CMD: 18-M12

Approve Regulatory Document

**REGDOC-1.1.1, *Site  
Evaluation and Site  
Preparation for New  
Reactor Facilities***

Submitted by:  
CNSC Staff

Figure 1: The role of site evaluation in the CNSC regulatory process

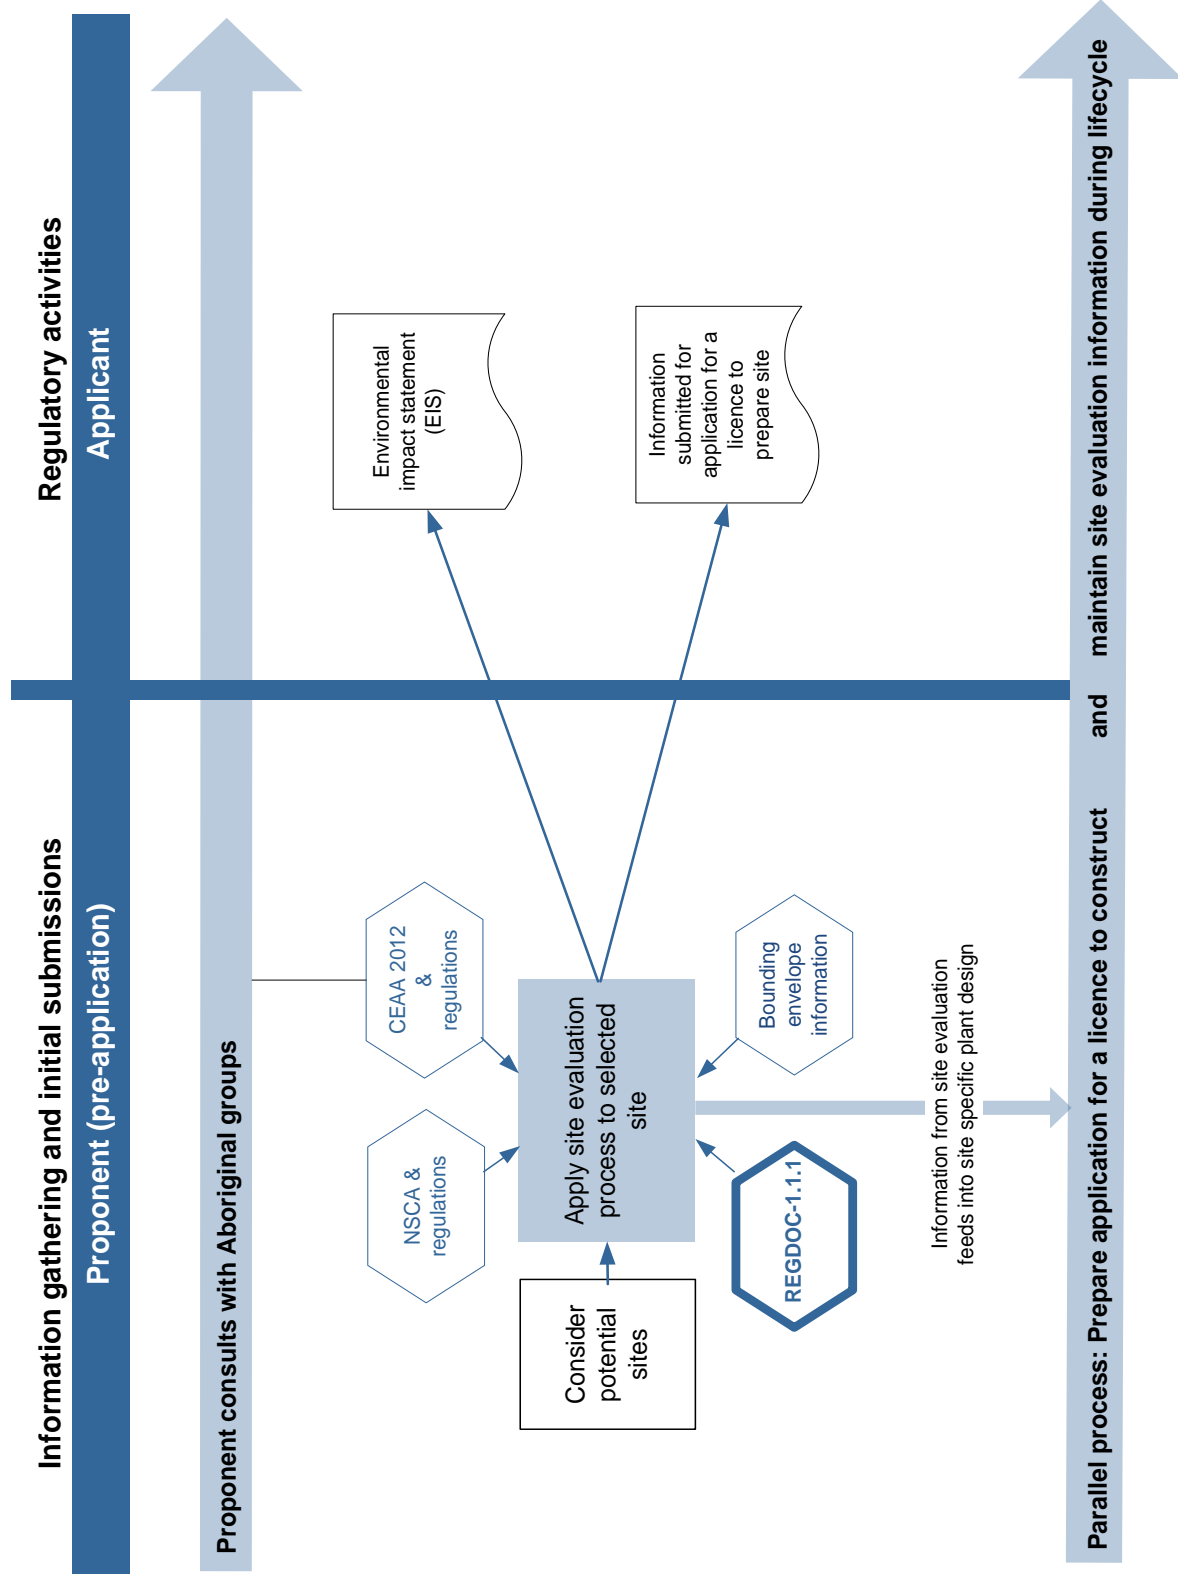
71.	Bruce Power, NB Power, OPG, CNL	S. 16, Figure 16.1, p. 32	Typo. Crown's duty to consult should be subsection 5.2 instead of 5.3.	Thank you. Figure has been adjusted.
